Replacing the ThermoFlex Wide II Table Interlock Switches
Document number 709-00216A

Ian Skinner March 11, 2004

Figure 3: 100 Label

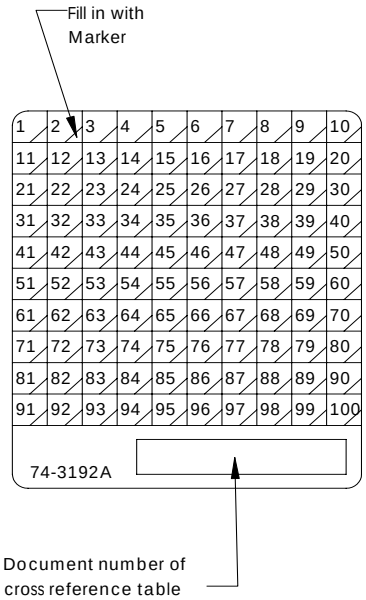
This upgrade procedure requires a 100 Label change. If the machine doesn't have a 100 Label on it, a blank label has been included in the upgrade kit. See Figure 3.

Apply the label and fill in position 1 using a black marker.
